Appl. No. 10/726,796
Amdt. dated December 30, 2004
Reply to Office Action of October 6, 2004

Amendments to the Drawings:

FIG.1

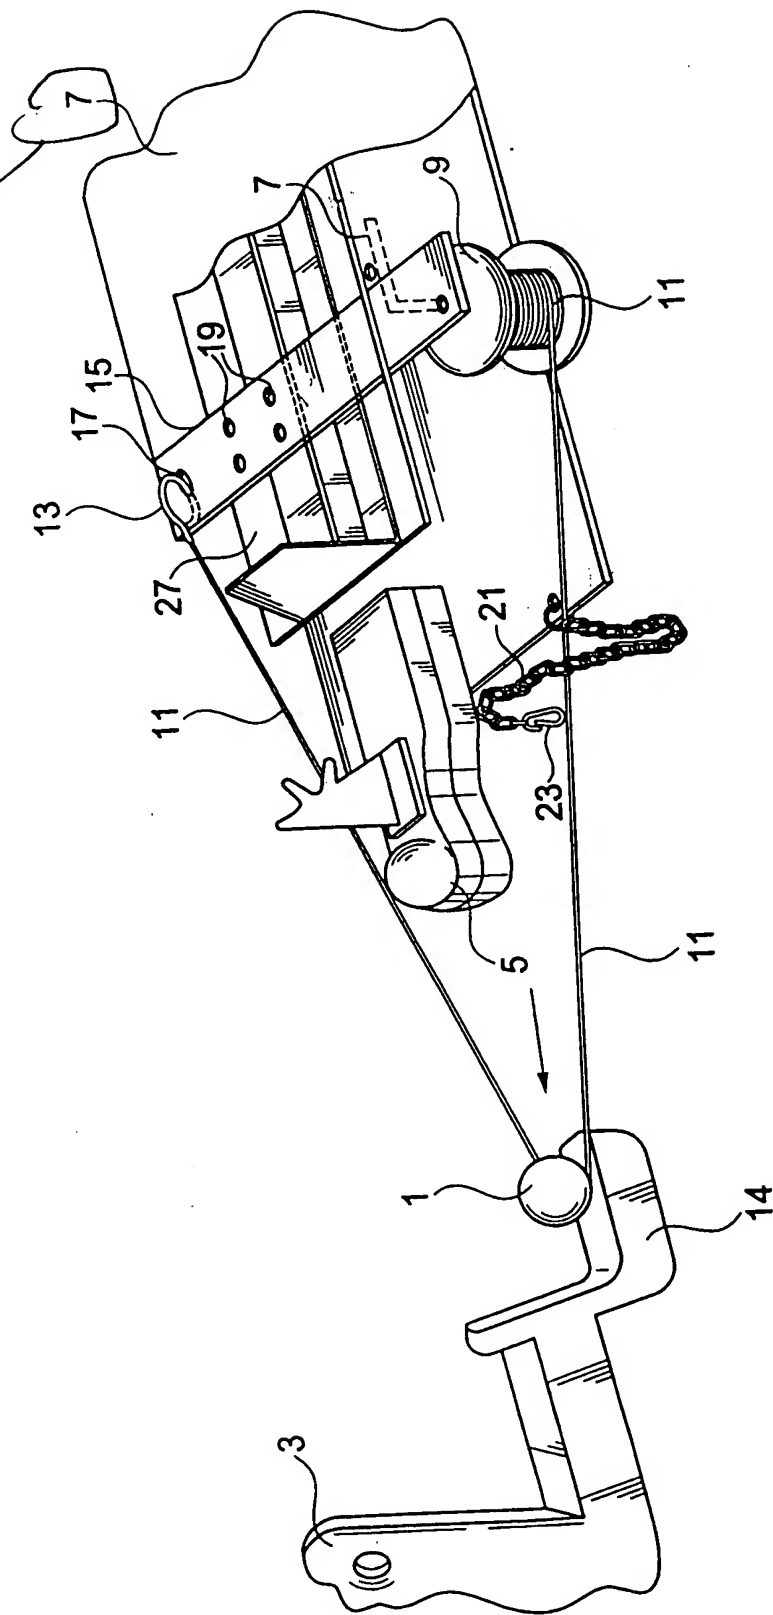
The attached drawing sheet includes changes to FIG. 1. This sheet replaces the original sheet that includes FIG. 1. In FIG. 1, one of the inadvertently duplicated references to item 7 has been removed.

*Duplicate
REMOVED*
